City of Santa Barbara California

PLANNING COMMISSION STAFF REPORT

PROJECT ADDRESS: 316-324 State Street/323 Anacapa Street (MST2005-00286)
Andalucia Building

SUBJECT: **CONCEPT REVIEW FOR 316-324 STATE STREET/323 ANACAPA STREET**

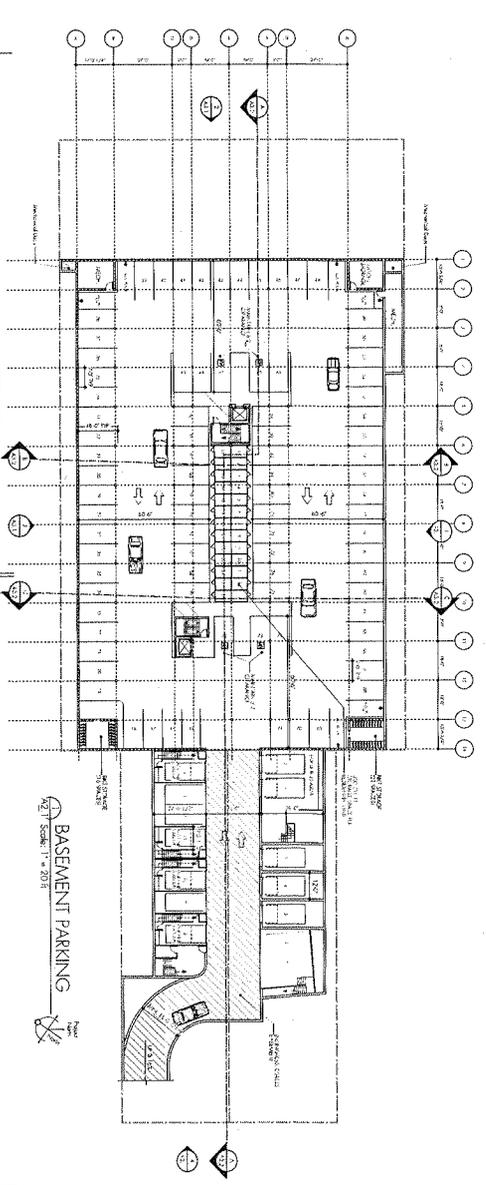
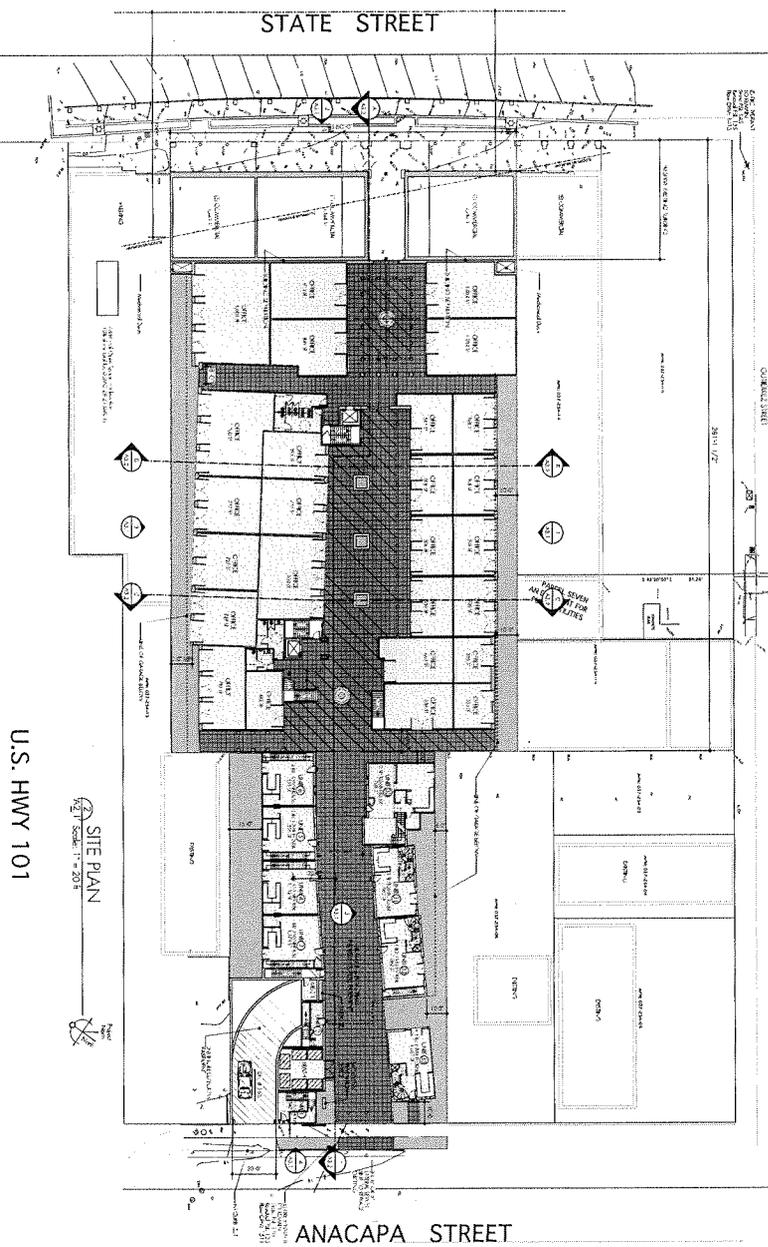
14. SBMC §28.21.080.F. requires that there be an open space area of not less than ten percent (10%) of the total lot area. The submitted plans indicate a cross hatched area on Sheet A2.1 as applying toward the 10% open space requirement. It is unclear whether this area meets the 10% open space requirement, please indicate on the plans all areas that qualify as part of the 10% open space and the square footage associated with these areas.
